ACCESSION NBR: 8608250106 DDC DATE: 86/08/21 NOTARIZED: YES DOCKET #  
 FACIL: 50-410 Nine Mile Point Nuclear Station, Unit 2, Niagara Moha 05000410  
 AUTH. NAME AUTHOR AFFILIATION  
 MANGAN, C. V. Niagara Mohawk Power Corp.  
 RECIP. NAME RECIPIENT AFFILIATION  
 ADENSAM, E. G. BWR Project Directorate 3

SUBJECT: Forwards draft changes to Tech Specs, FSAR & SER re inconsistencies for Unit 2.

August 21, 1986  
(NMP2L 0836)

Re: Nine Mile Point Unit 2  
Docket No. 50-410

FIGURE 6.2.1-1 NIAGARA MOHAWK  
MANAGEMENT ORGANIZATION CHART

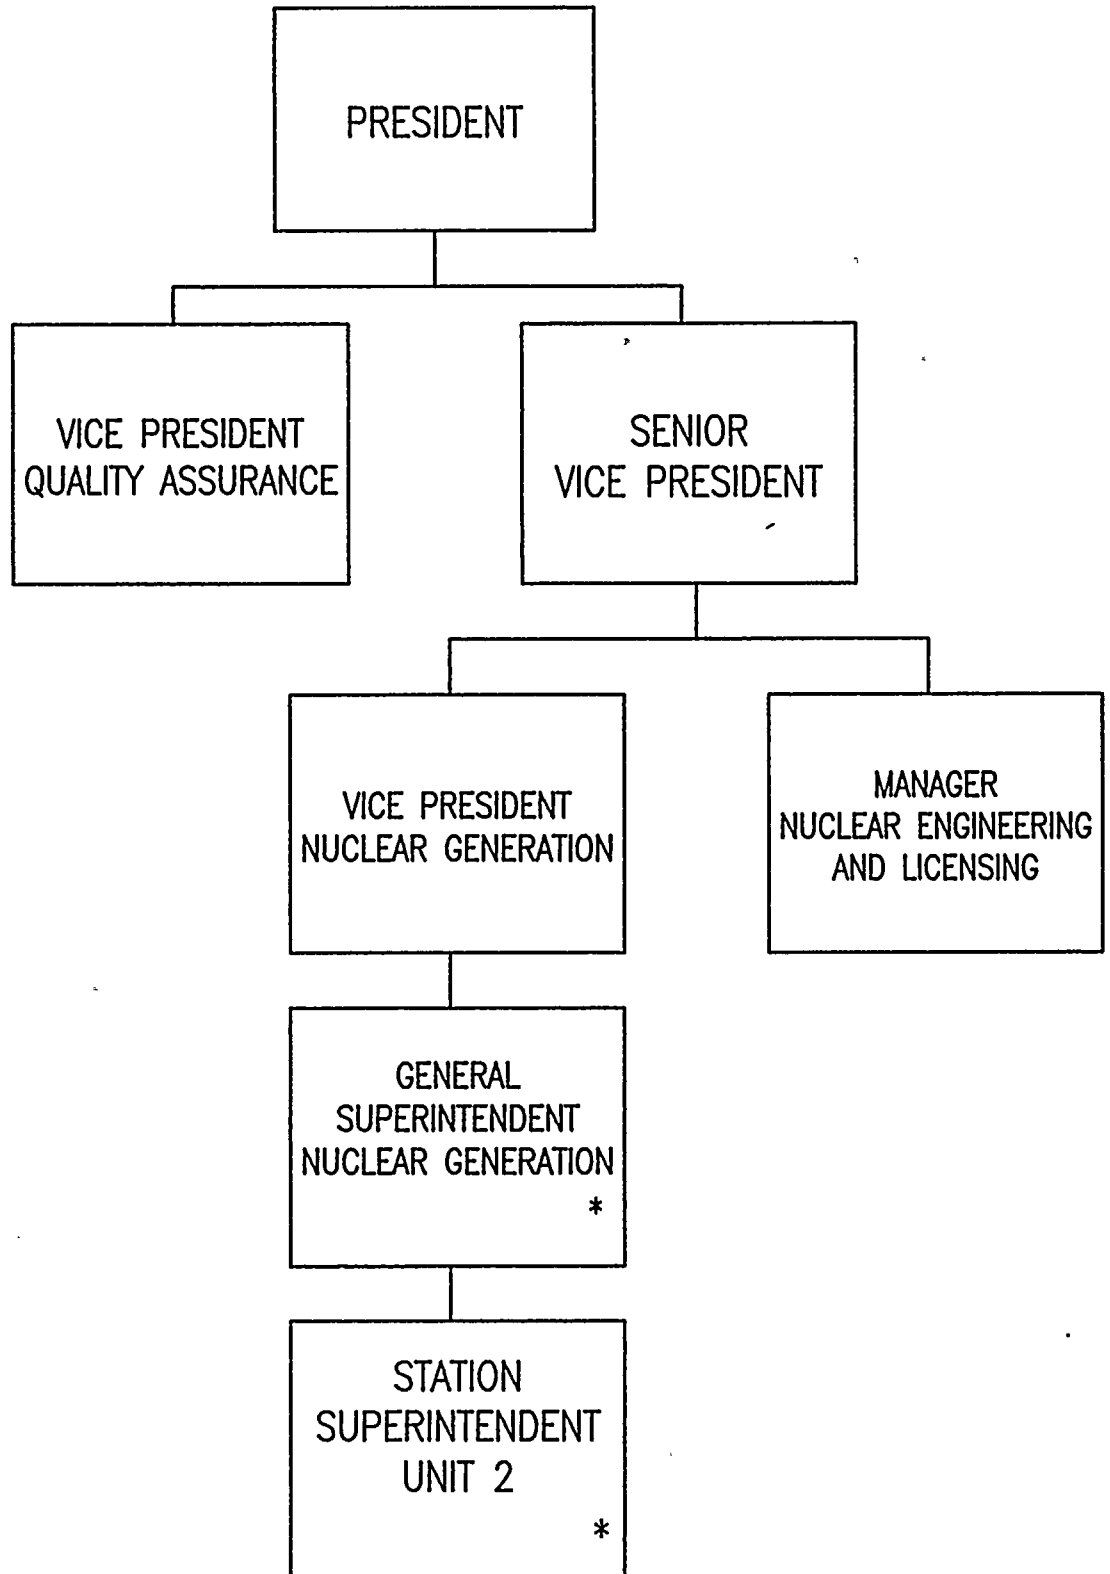
9. In this letter changes were made to Final Safety Analysis Report figures 13.1-6, 13.1-7, 13.1-8 and 13.1-9 and Technical Specification figures 6.2.1-1 and 6.6.2-1. All these figures address the Niagara Mohawk management organization structure. The corresponding figures in Chapter 13 of the Safety Evaluation Report need to be revised to reflect the changes made to the Final Safety Analysis Report and the Technical Specifications.

FIGURE 13.1-7  
 TECHNICAL ORGANIZATION  
 NIAGARA MOHAWK POWER CORPORATION  
 NINE MILE POINT-UNIT 2  
 FINAL SAFETY ANALYSIS REPORT

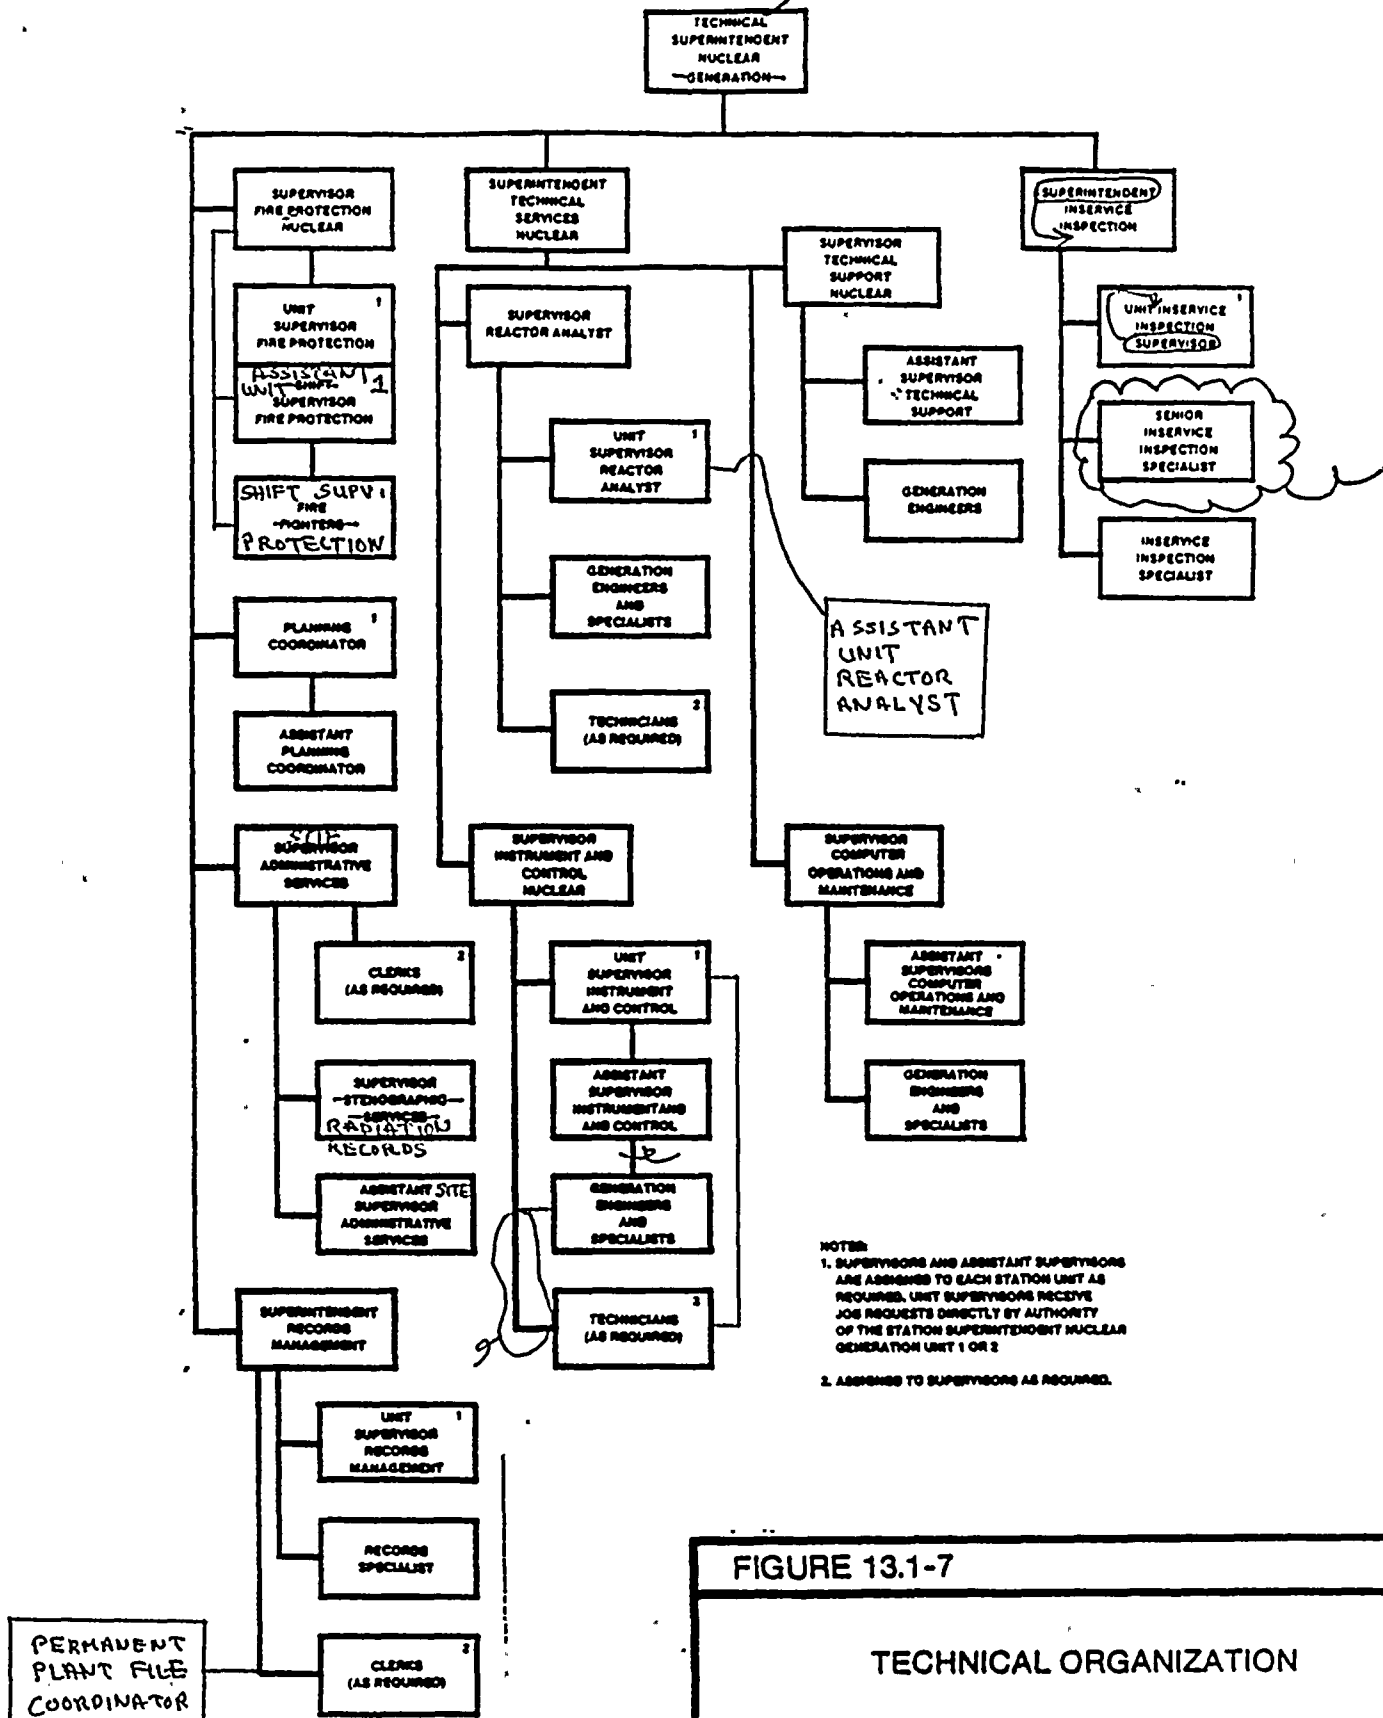
*replace with attached*
